**Cogentrix Quail Brush Generation Project - Docket Number 11-AFC-3, Data Request Responses to Set 3: Data Requests 65 through 70**

Pursuant to the provisions of Title 20, California Code of Regulation, Quail Brush Genco, LLC, a wholly owned subsidiary of Cogentrix Energy, LLC, hereby submits the *Data Request Responses to Set 3 for the Quail Brush Generation Project*. The Quail Brush generation Project is a 100 megawatt natural gas fired electric generation peaking facility to be located in the City of San Diego, California.

These six responses were compiled in response to the Energy Commission's QUAIL BRUSH GENERATION PROJECT (11-AFC-3), Staff's Data Requests, 65 through 70, dated April 5, 2012 and posted on April 17, 2012. This document provides additional information necessary to fulfill the Application for Certification data requests for the following technical areas:

**Figure 4.5-10 Photographic Simulation, KOP 1/Viewpoint 5, Mission Gorge Road.**

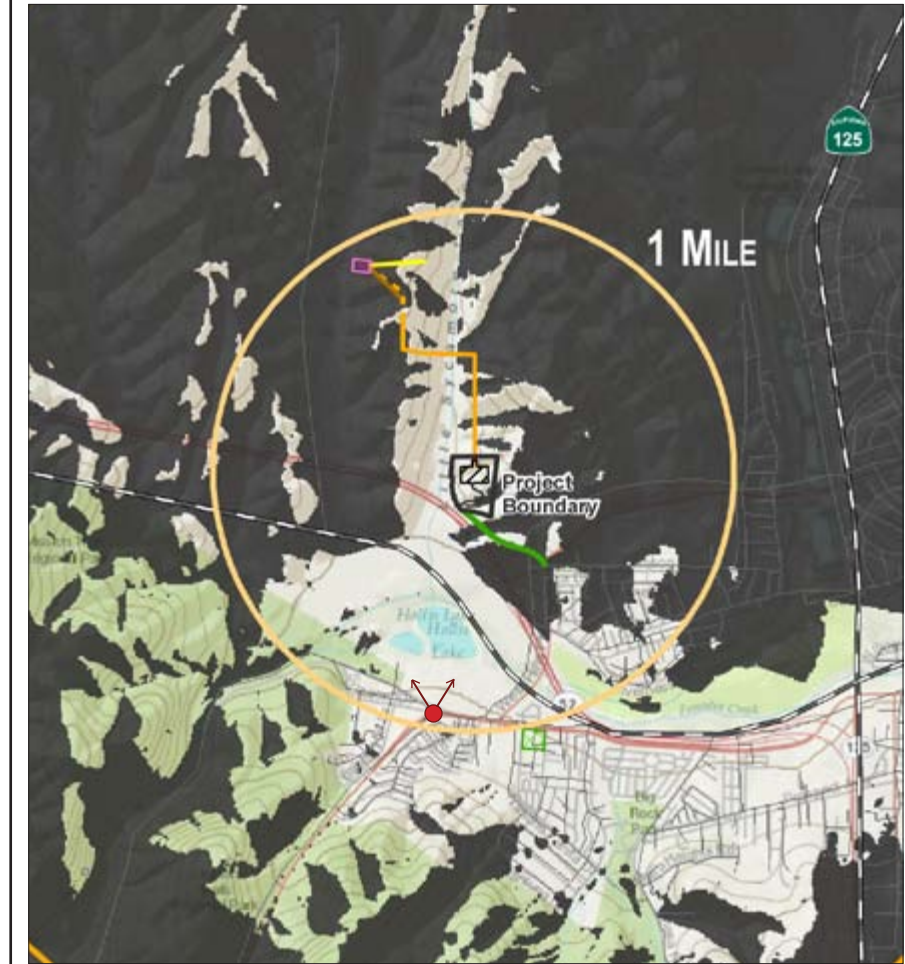
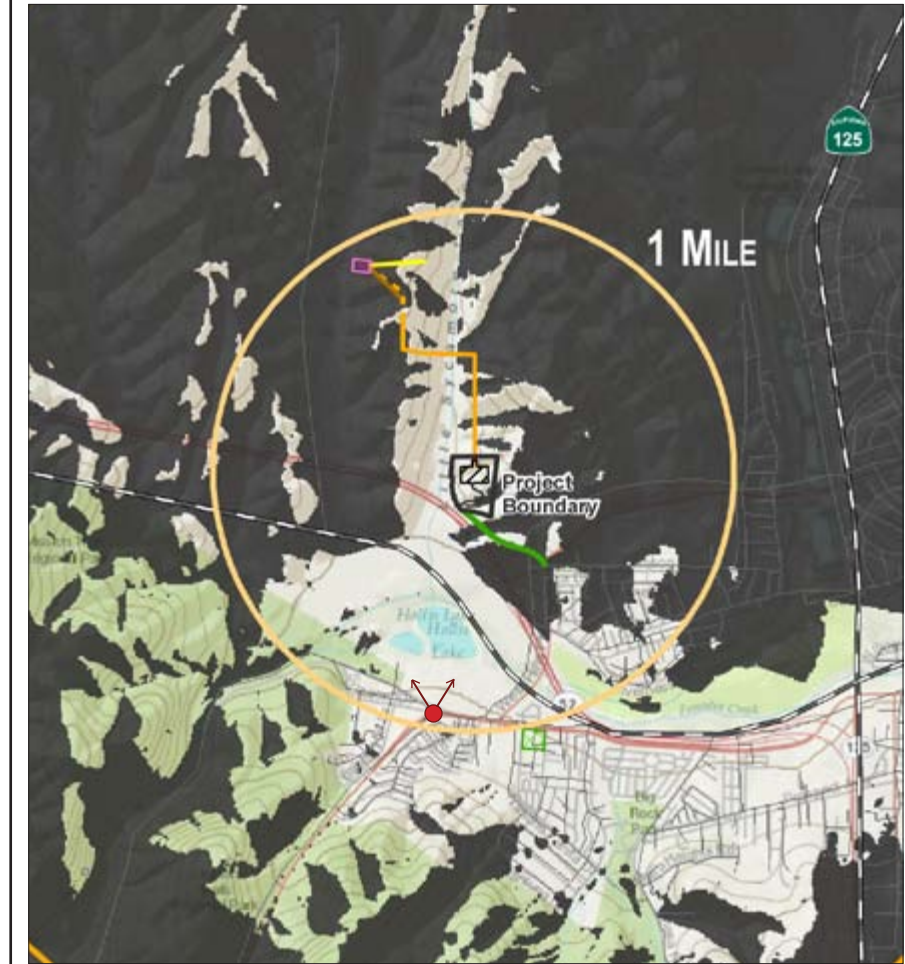
68. Please provide an electronic file that contains key observation point 1 (KOP 1) showing the existing condition without the proposed project capable of color print out on 11"x 17" sized paper.

69. Please provide an electronic file that contains KOP 1 showing the existing condition that includes the photographic simulation of the proposed project capable of color print out on 11" X 17" sized paper.

Figure 4.5-10, Photographic Simulation Key Observation Point 1 (KOP 1)/Viewpoint 5, Mission Gorge Road, shows the existing condition without the proposed project capable of color print out on 11"x 17" sized paper scaled to view 18 inches from your eye for real life scaling.

Figure 4.5-10, Photographic Simulation Key Observation Point 1 (KOP 1)/Viewpoint 5, Mission Gorge Road, shows the photographic simulation of the proposed project capable of color print out on 11"x 17" sized paper scaled to view 18 inches from your eye for real life scaling.
